Public Service Company of Colorado

May 16, 1986 Fort St. Vrain Unit No. 1 P-86366

SUBJECT: Fort St. Vrain Control

Room Design Review Summary Report

ATTACHMENT B (Page 1 of 2)
Section of Elevation
Drawing Showing Existing
Configuration of I-7507X

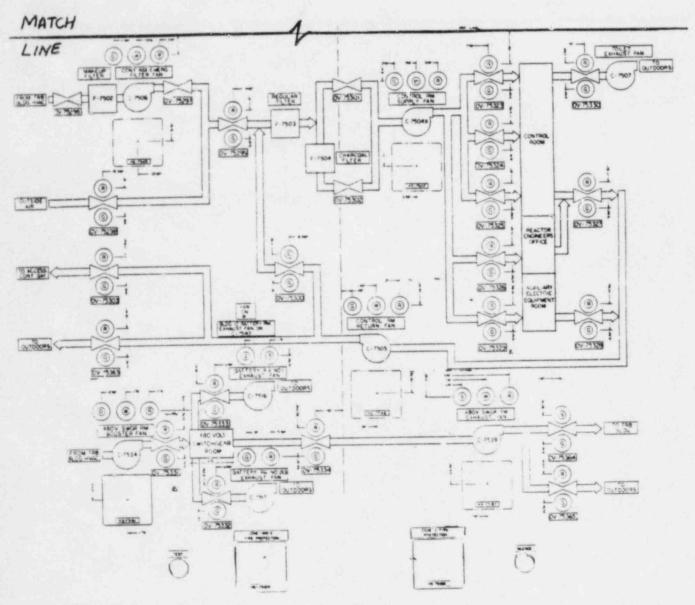
| USESTIONS: L.SINCE THE 480 V. SWER RM HVAC IS A RELATED SPACE ON PANEL DOES PERSONNE THIS SYSTEMS MADE LINE IN THE THE MUSIC LINES FOR THE 3-ROOM COMPLEX ADEQUATE? TO PROPOSED TO DELETE / AMMINIATION AS SHOWN AND A SESSIONS (Include Respondent's Name) L. "No Problem Deleting 480 V Rm Music Lines" "WE ONLY NEED STATUS LIGHTS FOR Dampers | 1203 THE SIMME SYSTEMS AND SHOPE ARE LEGENDS AND | P & I NO. |

- 1. LAYOUT IS ACCEPTABLE AS PROPOSED
- 2. A LAMP TEST BUTTON WILL BE APPED FOR DAMPER POSITION INDICATORS
- 3. FILTER HOUR METERS SHOULD BE LOCAL, NOT IN CONTROL ROOM
- 4. THERE IS NO NEED FOR HIGH TEMP ALARMS ON CONTROL ROOM CHARCOAL FILTERS

- Indicators TI-7557, MI-7554, PDI-7556, TI-7553, and TI-7555 are relocated from I-15 to I-7507X.
- Position indicator lights added to mimics for DV-75301 and DV-75302 to show use of charcoal filter.
- Position indicator lights added to mimics for DV-75296 and DV-75297 to show use of make-up filter.
- Lamp test button for indicating lights.
- Summary lights for 480V Room Damper Modes.
- 3. Functionally group all controls, related indicators, and alarms.
- 4. Rescale indicators.
- 5. Revise Control/Aux Electric Rooms Mimics:
 - Damper symbols to replace valve symbols.
 - Position indicators for Dampers to follow conventions.
 - Due to additional space needed for Control/Aux Rooms Mimic, 480 V Switchgear Room Mimic will be deleted. Damper position indicators will be relocated on I-7507X to show Damper line-up.

ATTACHMENT C
Examples of
Proposed Location
Aids & Labeling

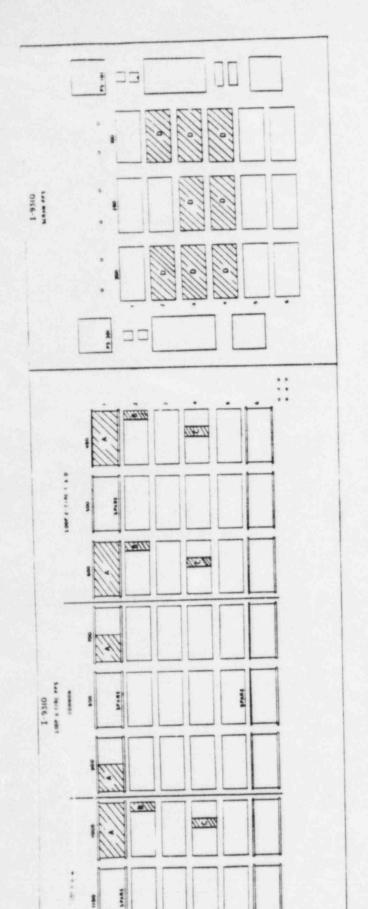
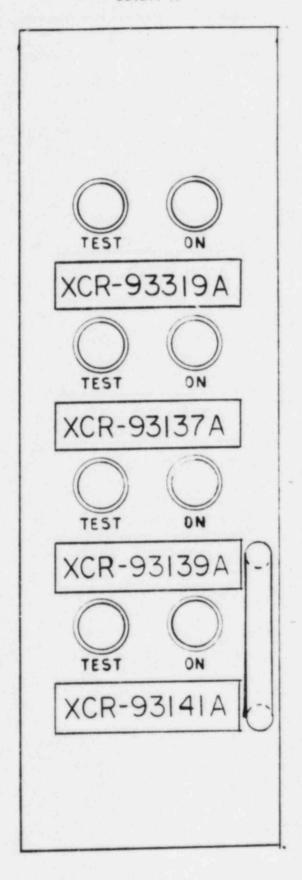
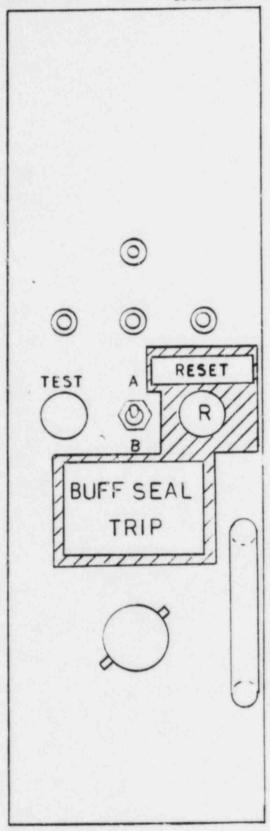
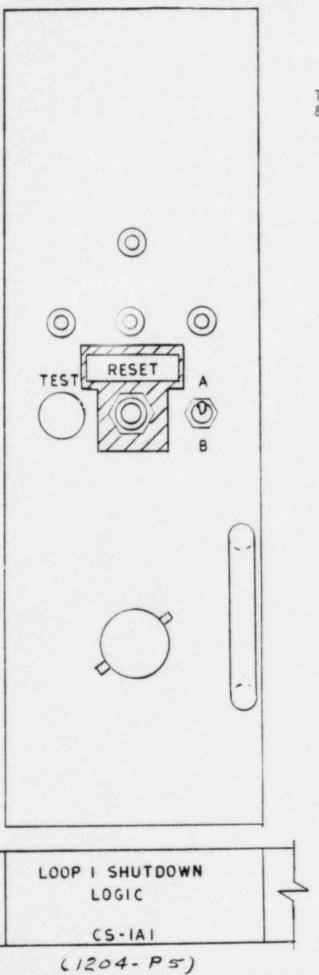
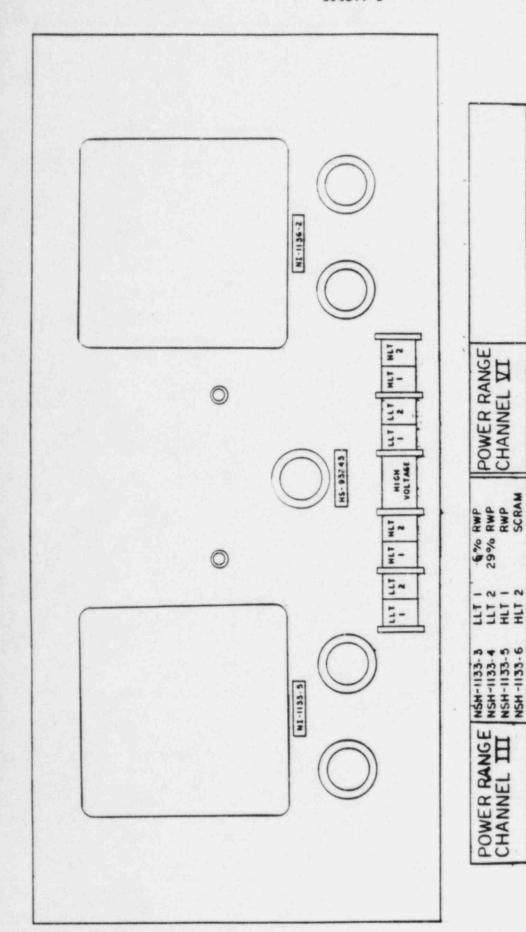
Conceptual Design - Detail drawings were made of the modules required during emergency operations. The original design did not provide for a reset button conforming to recommended sizes nor adequate labeling to enable timely operator identification. The proposed improvement will demarcate around the control, color patch and provide a "reset" label. Additionally, the module will be provided with adequate functional labeling. These "location aids" are shown on Attachment C. Details B & C.

Provide Instrument Label for Meters & RWP Switch. Increase Height of Bin Label to 1 1/4" and Increase Letter Size to 5/32".

- 2. Provide instrument labels to identify XCR outputs.
- Provide instrument number identification labels for Rod Withdrawl Prohibit Selection Switch on Nuclear Instrumentation bins 104, 204, and 304.
- 4. Correct labels with functional description discrepancies.
- 5. Add missing functional labels.
- 6. Provide demarcation and hierarchial labeling as practical.
